Highlights of Technical Analysis for TexCom's Permit Application WDW-410 Class I Well

An Oversight Exercise by EPA, Region 6

Highlights of Technical Analysis for TexCom's Application – WDW-410 Class I Well

A Discussion on Relevant Parameters, Parameter Values, Injection Reservoir Pressure Build Up Modeling, Aquifer Contamination Risk Assessment for Permitted Operation and UIC Program Performance Assessment

Reservoir Permeability k in the Lower Cockfield From Fall-Off Test Data

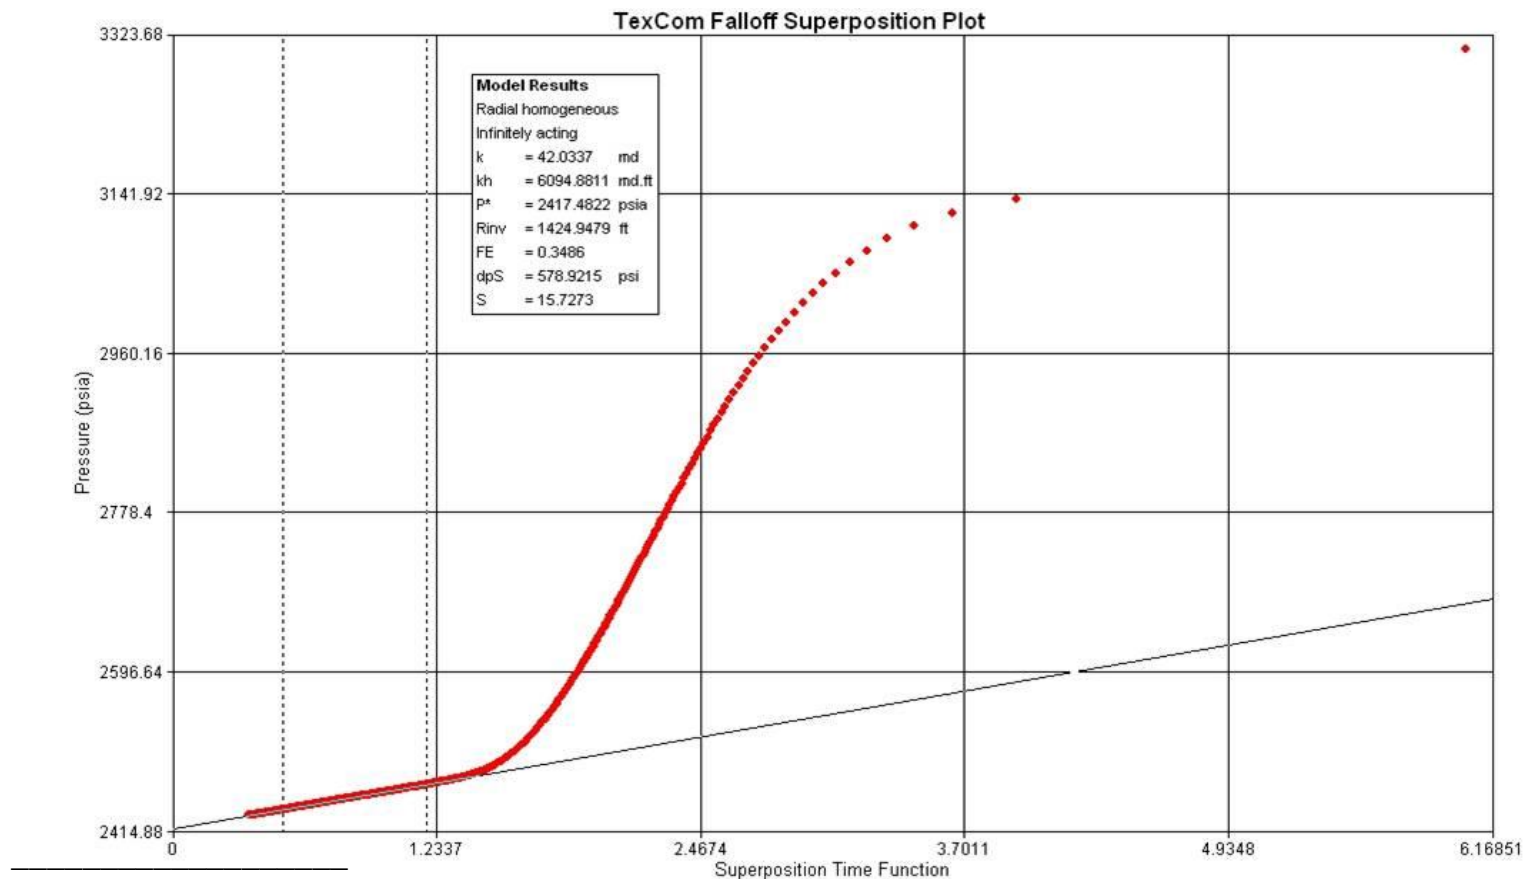
The WDW-410 well was worked over in September, 2009. New perforations were added above the existing perforations, bringing the total thickness of the injection interval to **145 Ft.** A fall-off test followed, and the results of the test analysis (illustrated above) indicated a permeability of **42 md** for the Lower Cockfield tested interval.

Region 6's Pansystem software was used to analyze the test data, which estimated the viscosity of the reservoir water at **0.364 cp**, based on the observed bottom hole temperature and input water salinity of **80,000 ppm**.

EPA considered the test results to be representative, and recommended they be honored.

Reservoir Porosity \neq in the Lower Cockfield From Log Data

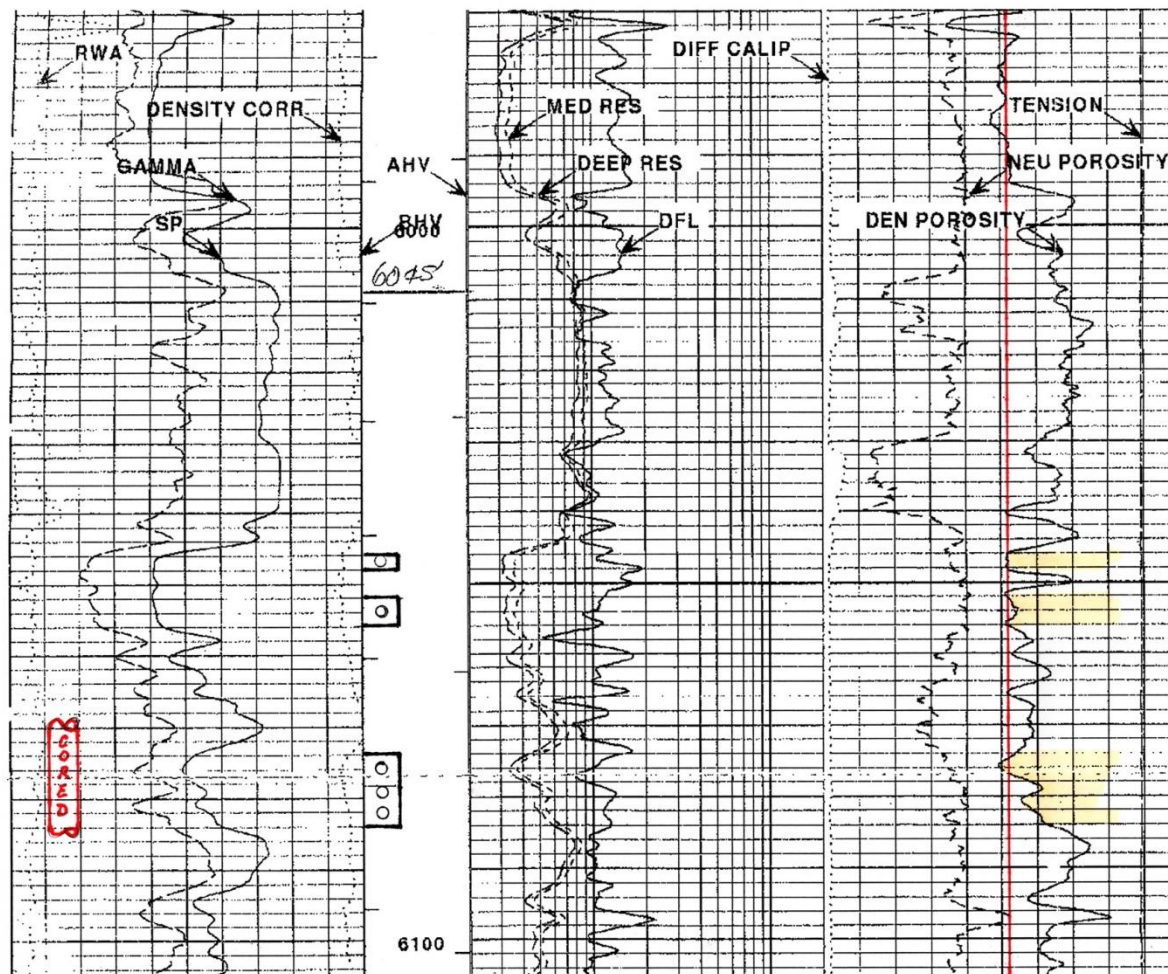
A composite well log was available for the WDW-410 well from the operator. A Lower Cockfield segment of this log is illustrated above. The red line amid the Neutron-Density porosity curves marks the 29 % porosity to emphasize the deviation of the density porosity from this value across the entire thickness of the Lower Cockfield, the injection zone. The following two slides show the log segments for the remainder of the Lower Cockfield.

Reservoir Porosity Ø in the Lower Cockfield From Log Data

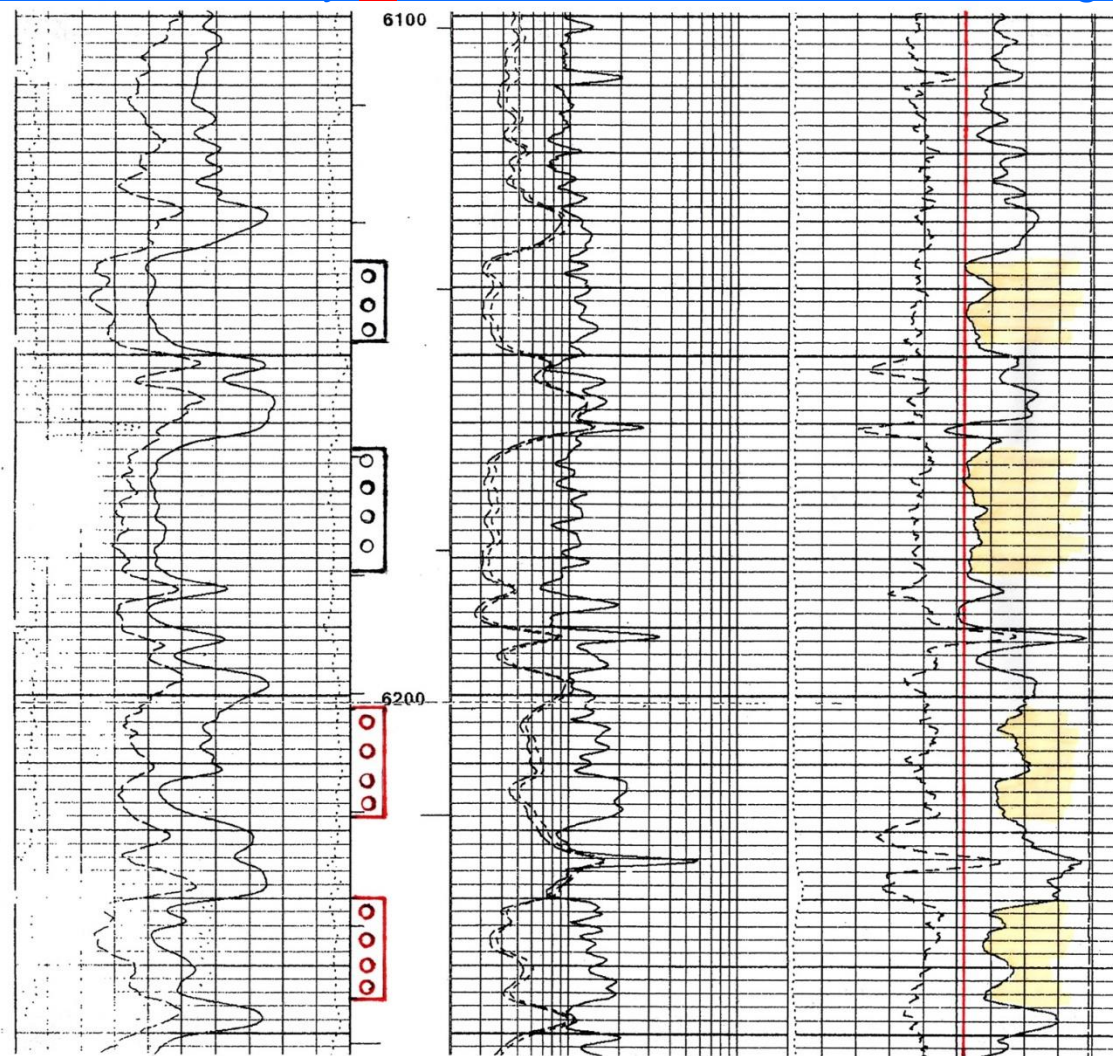
The perforated intervals are marked in the “Depth” track of the log. The red marks represent the original completion perforations, and the black marks represent the perforations added in 2009.

Reservoir Porosity \emptyset in the Lower Cockfield From Log Data

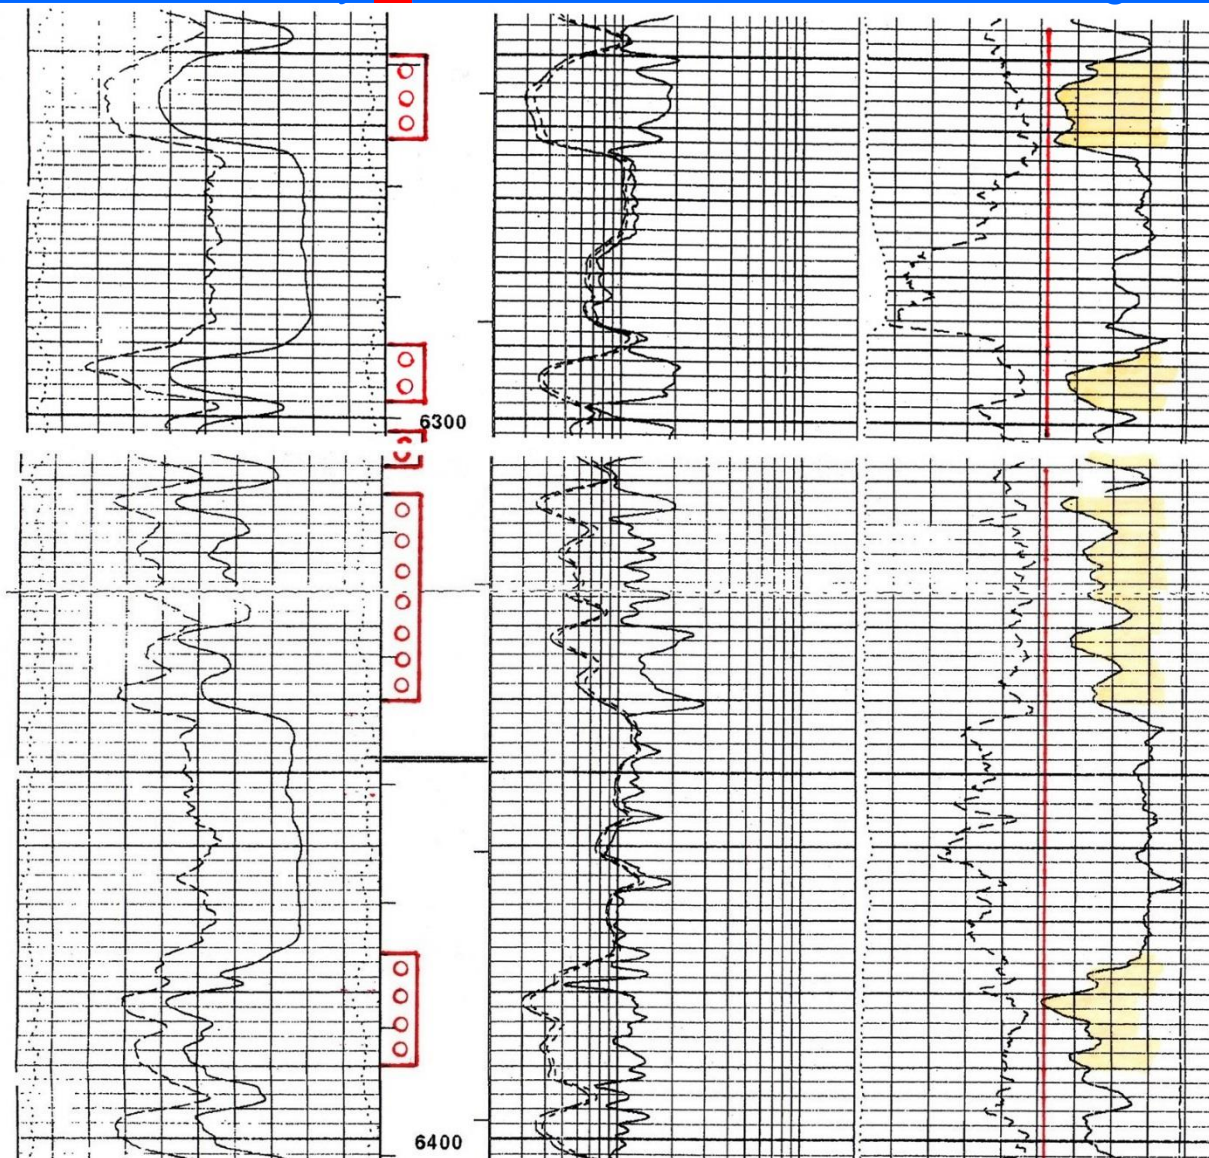
In the above log segments, the Lower Cockfield porosity rarely reaches a value of 30.1 %. Segments of the composite log were digitized for the three components of the Cockfield formation for use in quantitative analysis.

Fig. D.13 is taken from
“How Temperature Affects Viscosity of Salt Water”, *World Oil* (Aug. 1, 1967) 68.

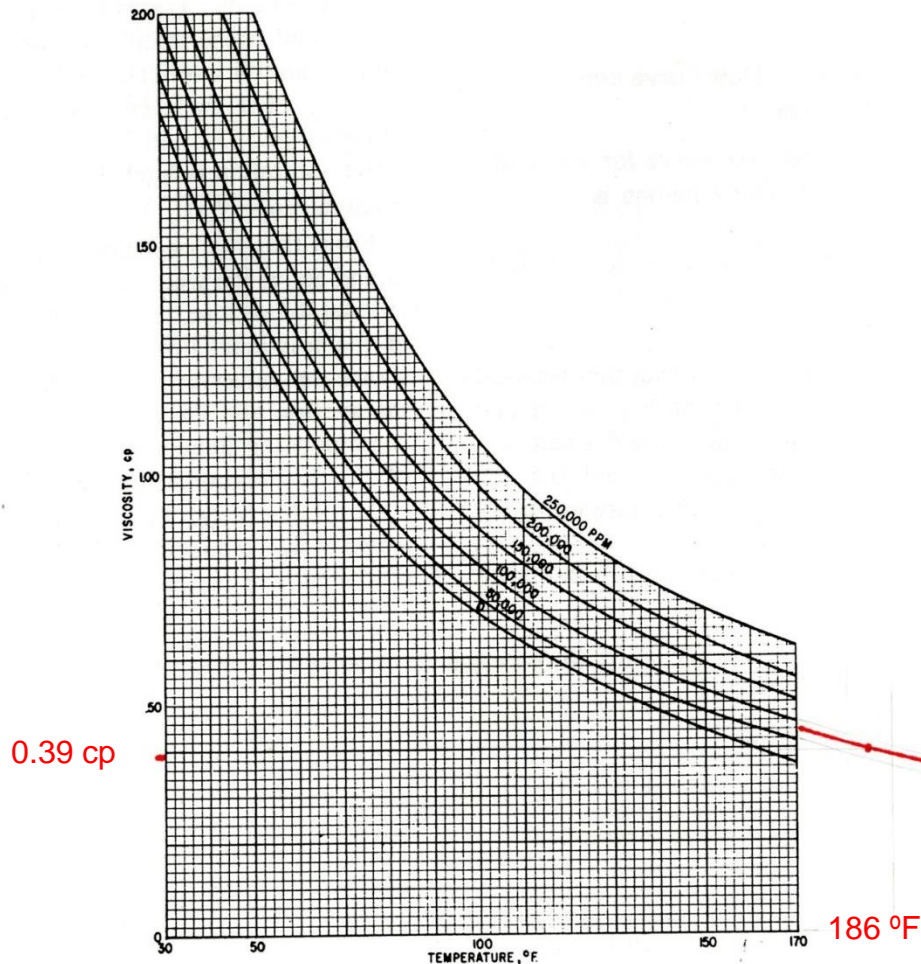
Now, the shown graph depicts how water viscosity varies with temperature and salinity.

In order to accommodate the higher temperature value for the Lower Cockfield, some extrapolation has been necessary.

The estimated viscosity for 80,000 ppm water at 186 °F is 0.39 cp, per the shown graph.

This estimated value for the Lower Cockfield at the WDW-410 well compares favorably with that of 0.364 cp estimated by R6's Pansystem software, previously referenced in this discussion.

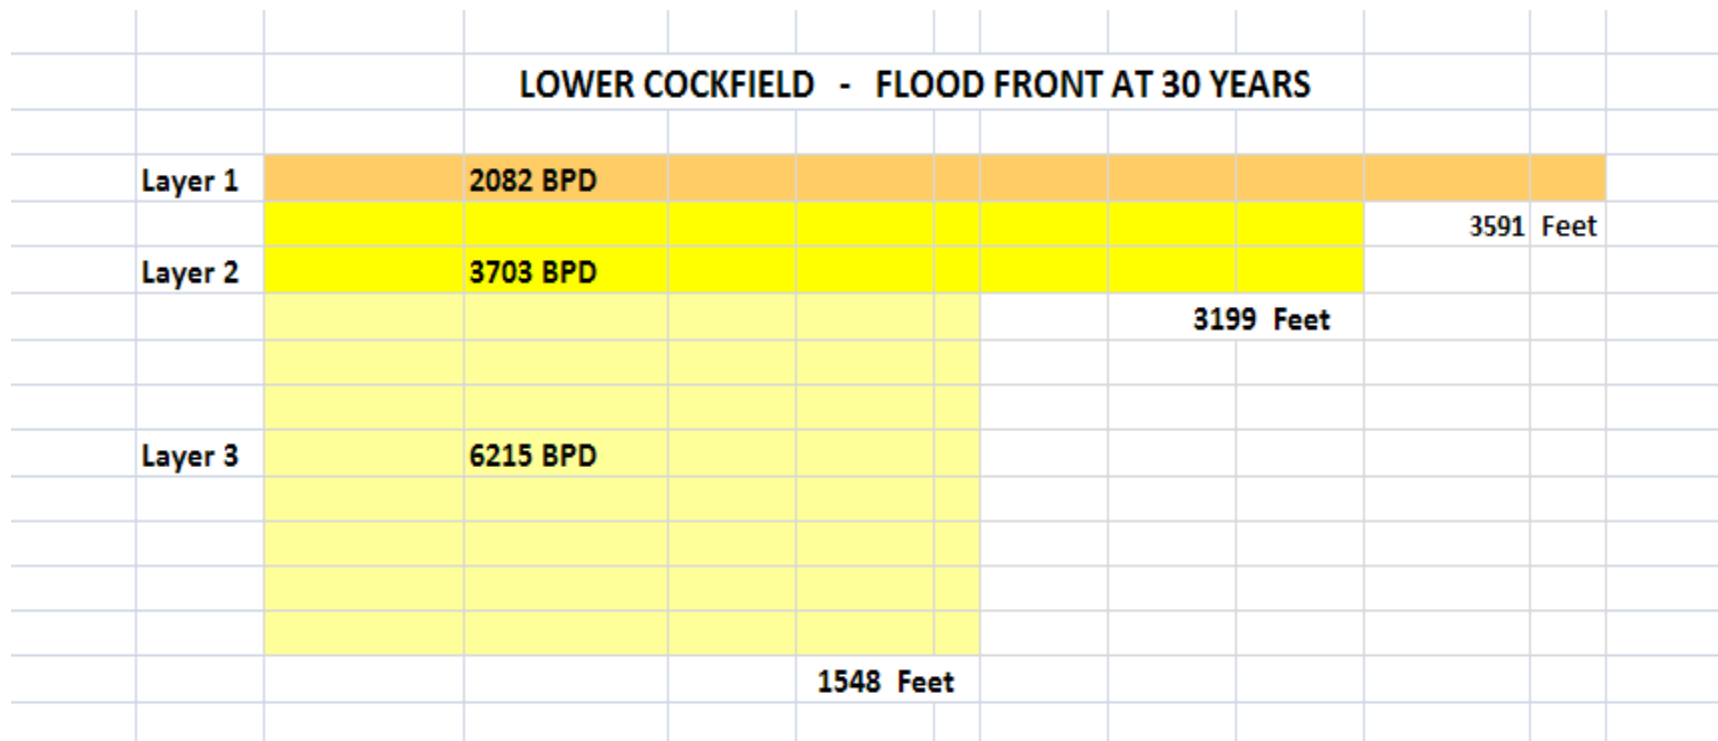
The previous discussion on viscosity of fluids in a reservoir shows why the viscosity value of 1.26 cp proposed by the operator for the Lower Cockfield in the Conroe field can not be validated with engineering principles and practices or supported with the available data. I am not sure that anyone challenged this piece of information, though I know that there were comments stating that our proposed value was too low. However, I never got to see a justification for such comment.

The reservoir fluid viscosity is a very important factor in the outcome of the reservoir pressure build up predictions and in the assessment of the risk posed by an injection operation. I believe every effort should be made to arrive at the correct value.

FIGURE VII-6

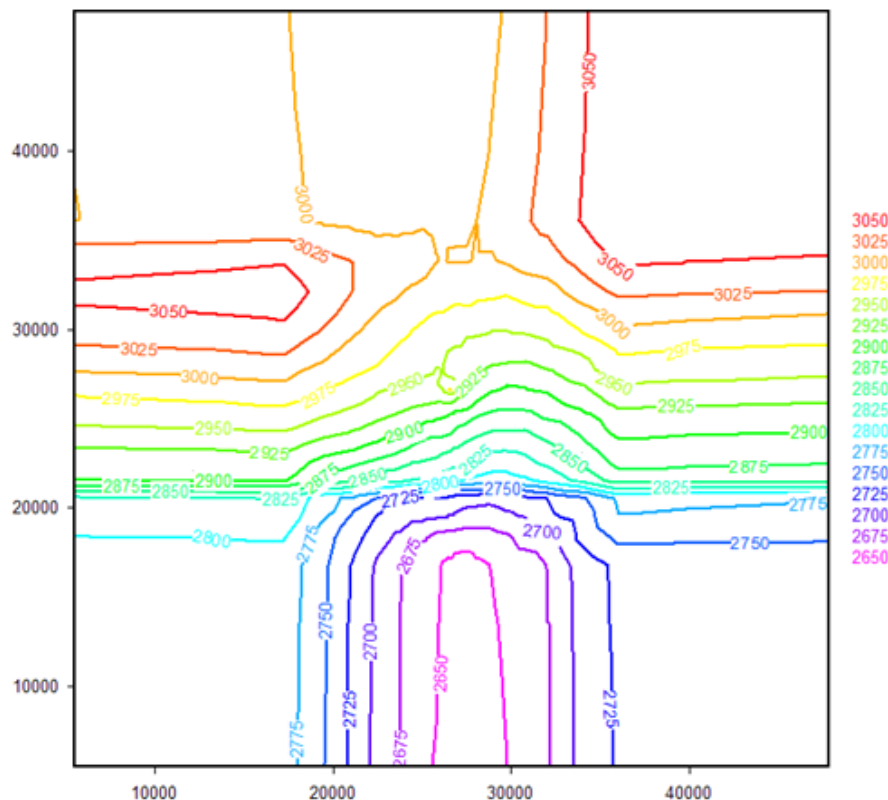
Figure VII-6 in the application package was intended to illustrate the reservoir pressure profile at the end of the project's life. The iso-potential lines in this Figure suggest reservoir flow patterns associated with lines of Injectors (line drive patterns) rather than the typical radial flow pattern around one single injection well, or a closely spaced cluster of injection wells. The point in bringing up this Figure for discussion is to illustrate situations that ought to have triggered questioning the validity of submitted information in a case like this. Apparently, no red flags were raised because of this anomalous piece of information.
